■ MULTIPLEX COMMUNICATION SYSTEM

1. Major Difference

08E5NF13C

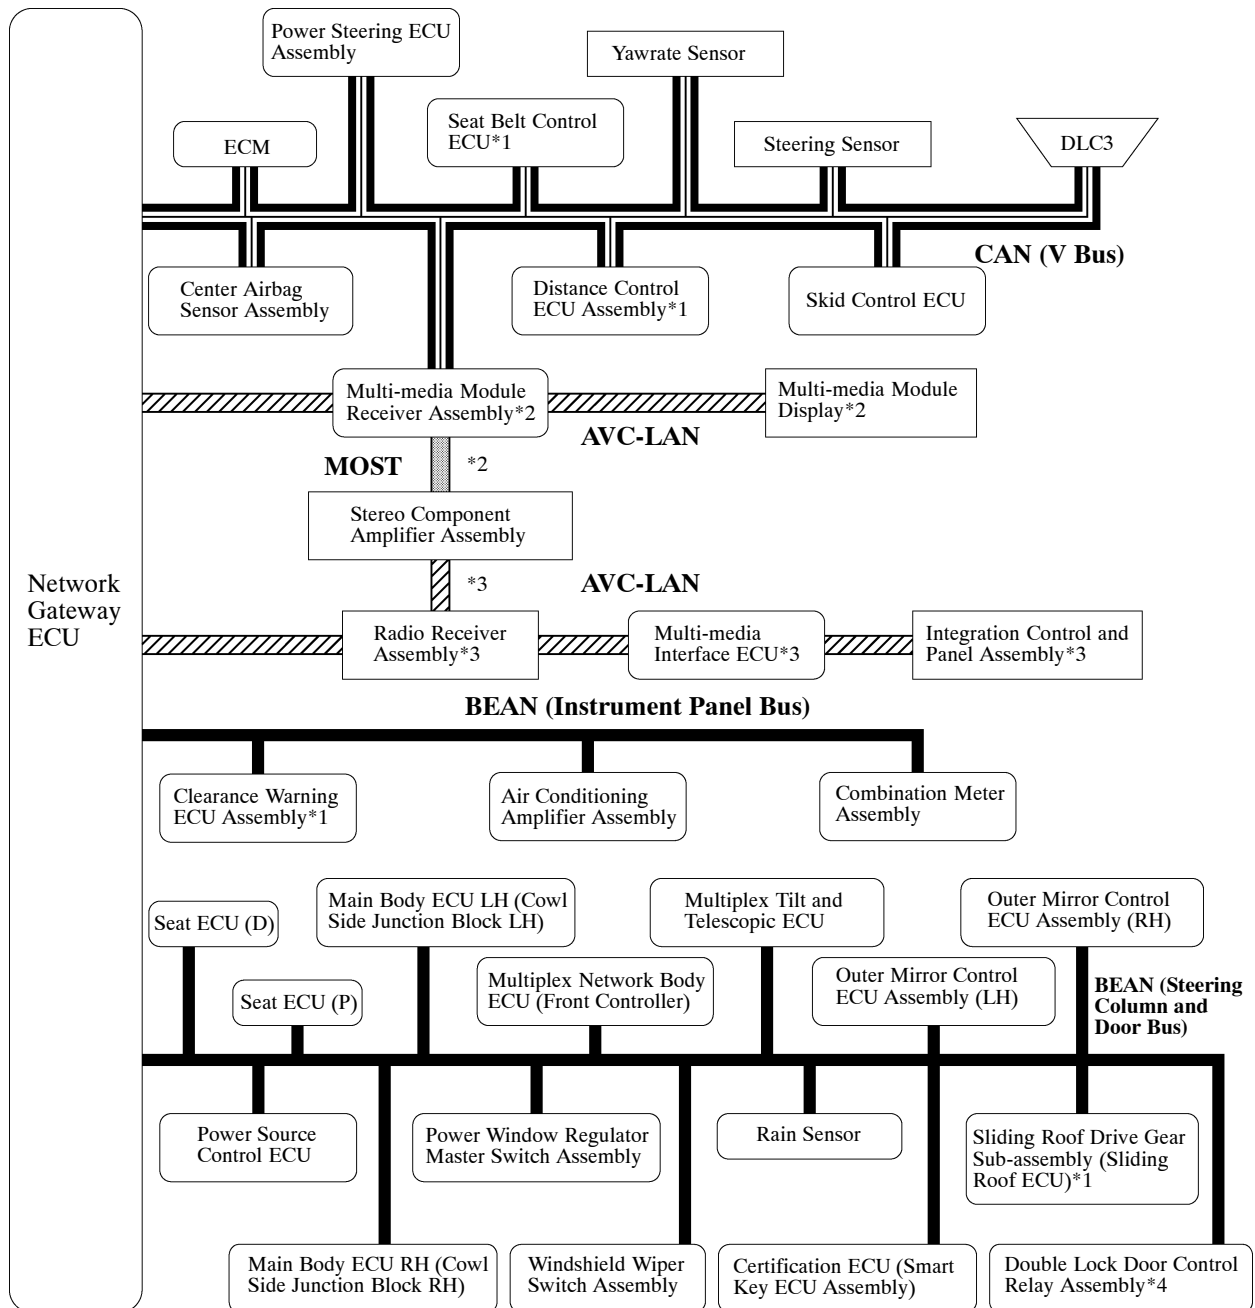
In accordance with the adoption of a new model HDD navigation system, the configuration of the AVC-LAN and MOST has been changed and the parking assist ECU has been discontinued.
